MICROCHIP PIC18F2410/2510/4410/4510

PIC18F2410/2510/4410/4510 Rev. A1 Silicon Errata

The PIC18F2410/2510/4410/4510 Rev. A1 parts you have received conform functionally to the Device Data Sheet (DS39636C), except for the anomalies described below. Any Data Sheet Clarification issues related to the PIC18F2410/2510/4410/4510 will be reported in a separate Data Sheet errata. Please check the Microchip web site for any existing issues.

FIGURE 1: SCK PULSE VARIATION USING TIMER2/2

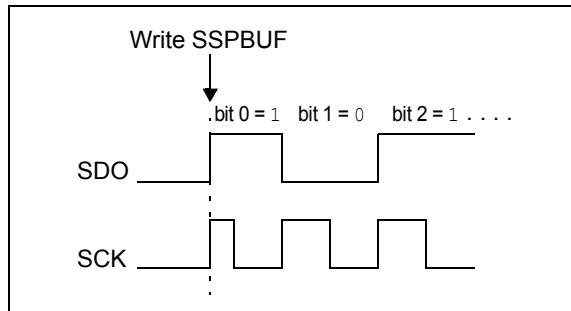
When the SPI is using Timer2/2 as the clock source, a shorter than expected SCK pulse may occur on the first bit of the transmitted/received data (Figure 1).

To avoid producing the short pulse, turn off Timer2 and clear the TMR2 register, load the SSPBUF with the data to transmit and then turn Timer2 back on. Refer to Example 5 for sample code.
